**City of Sedona Community Development Department  
Engineering Services**

The City of Sedona, Arizona is issuing **Addendum # 3** to the plans and specifications as originally issued at the time of solicitation for bids for the **WWRP A+ Upgrades Project**. For any bid to be considered responsible and responsive, receipt of this addendum must be acknowledged.

*This Addendum changes the following:*

P342  
TYP **RESTRAINED DIP FLEXIBLE CONNECTION AT WALL PENETRATION** 08-01-05

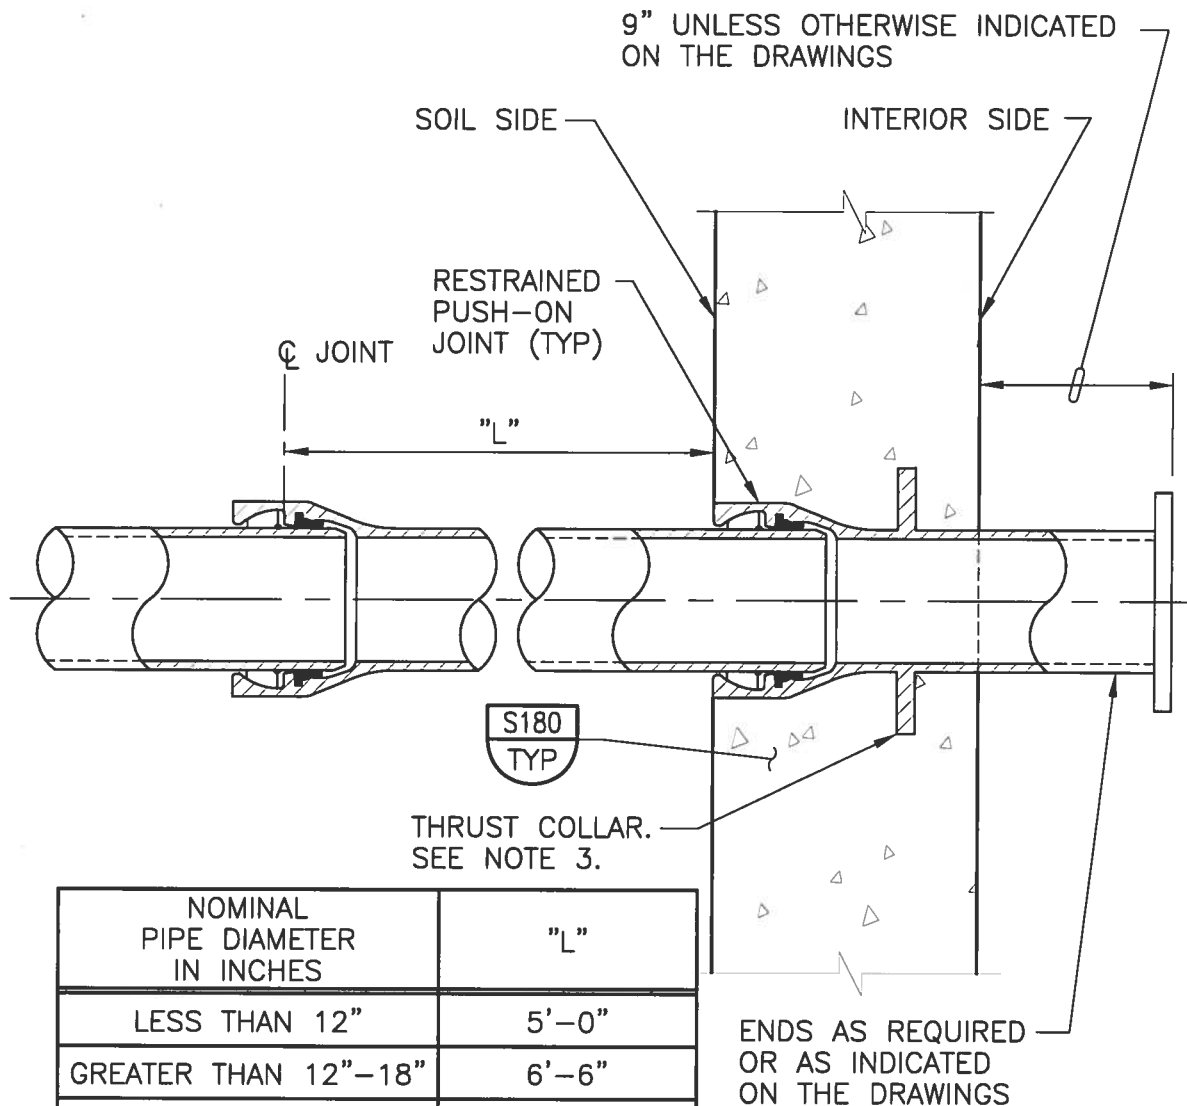
1. The pipe schedule in Specification 15052 shows PTW (poly tape wrap) for underground DIP lines. Correction: For buried ductile iron pipe, apply asphalt coating and PEE (polyethylene wrap) per Specification 15211. All references to PTW coating in the pipe schedule (Specification 15052) should be changed to PEE.
2. Per General Piping Notes, ALL piping entering or exiting structures require flexible connections. Restrained pipe system flexible connections shall be based on Typical Details P346 or P342 (attached) for corresponding pipe materials. Unrestrained pipe system flexible connections shall be based on Typical Details P340 or P348 for corresponding pipe materials.
